## Thor Motor Coach Technical Service Bulletin

TSB #	<b>TSB 21-02</b>		
Description/Title:	<b>VS/XS 24.3 Gray Tank Securement</b>		
Affected Product Line(s):	<b>Certain model year 2021 24.3 Axis and Vegas motorhomes</b>		
Service Campaign # :	<b>RC000215</b>	Released Date:	<b>3/24/2021</b>
Codes:	<b>Inspect Only: TMCTS80266Y</b>  <b>Inspect &amp; Repair: TMCTS80266W</b>	Document Date:	<b>3/24/2021</b>
Time Allowed:	<b>Inspect Only: 0.1</b>  <b>Inspect with Repair: 0.4</b>	Document Revision:	<b>A</b>

This procedure is to be used to add a “Z” bracket to the bottom of the rear-most cross member in the chassis of the 24.3 Axis/Vegas product. This new bracket is intended to replace the “Z” brackets that are currently installed near the top of the tank above the cross member because of inadequate backer in the unit floor.

**VIEW FROM BOTTOM SIDE OF COACH.  
BOTTOM OF FLOOR IS TRANSPARENT IN THIS VIEW TO SHOW FRAMING.  
THESE TUBES IN THE FLOOR WERE OUT OF POSITION.**

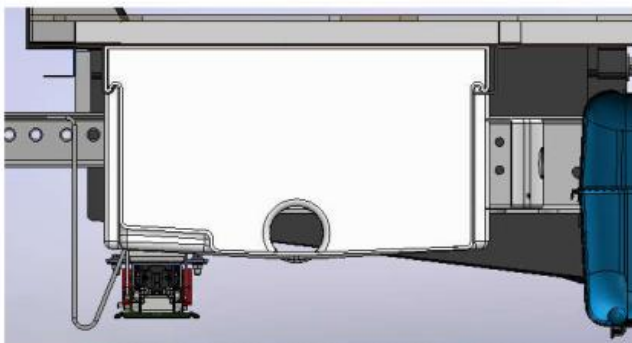
The steel tube backer in the coach floor may not have been installed in the correct location to adequately secure the gray water holding tank underneath the 2021 24.3 Axis & Vegas motorhomes.

**SECTION VIEW SHOWING HOLDING TANK IN POSITION ON  
COACH WITH ORIGINAL HARDWARE INSTALLED.**

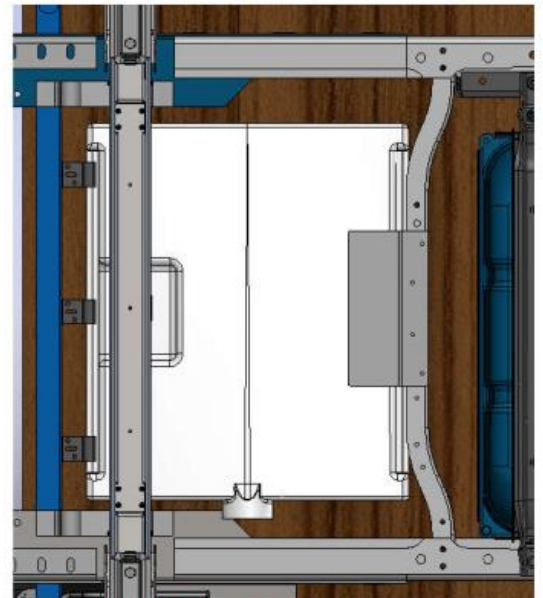
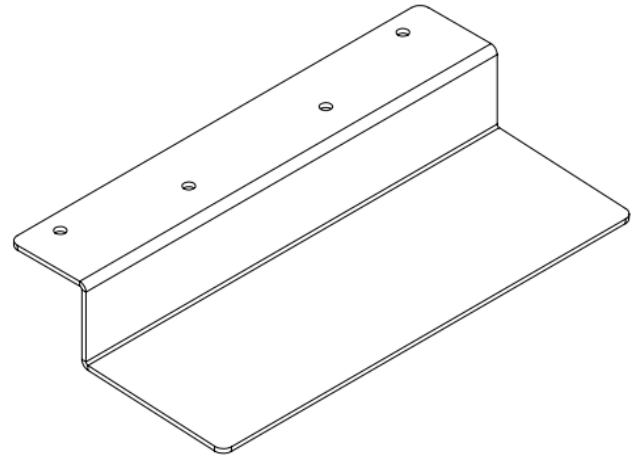
3. After new "Z" bracket is installed, remove any existing brackets that are screwed to the main unit floor along the front side of the tank. (Note the brackets on the rear side of the tank are to remain installed.) Discard removed brackets. Use Darco tape or black sealant to cover/fill any holes in the main floor where these brackets were installed initially. (Be sure to clean the Darco surface on the bottom of the floor before applying the tape over the holes.)

**IN THIS VIEW THE ORIGINAL BRACKETS ARE  
REMOVED AND REPLACED WITH TFM7247**

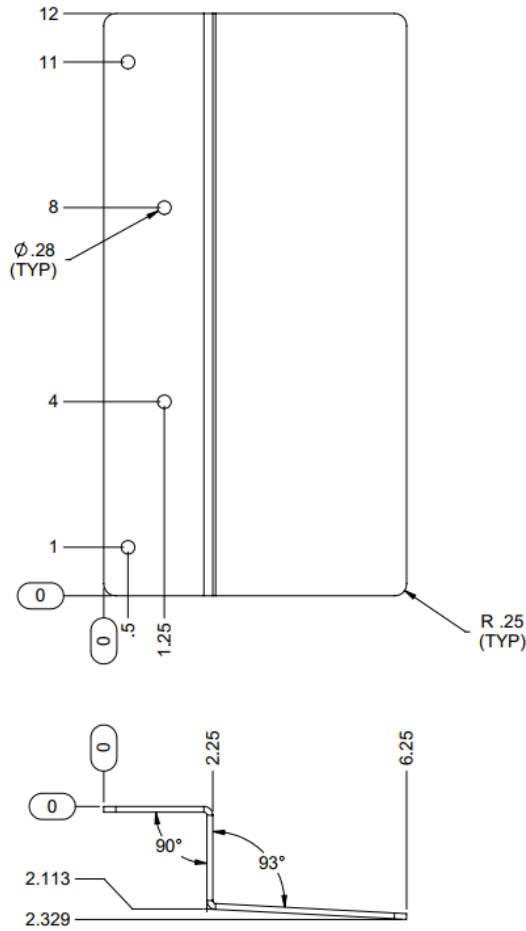
1. Verify that motorhome has the correct sized Z-bracket screwed into the chassis cross-member supporting the gray tank. It is a possibility that on some coaches the incorrect Z-bracket was installed during production. Confirm that the bracket is 12" wide as show on TFM7247 (See page #4).

1. Place new "Z" bracket (TFM7247) against bottom of cross member. The 12 x 2-1/4" face of the bracket with holes in it should be on the bottom of the cross member with the bottom of the "Z" going rearward on the unit towards the back of the tank. The bracket should be approximately centered from side to side on the unit.

2. Screw through the holes in the "Z" bracket into the bottom of the cross member through all four holes provided in the bracket. Use (4) 1/4" hex head self-tapping screws 3/4" long for this.
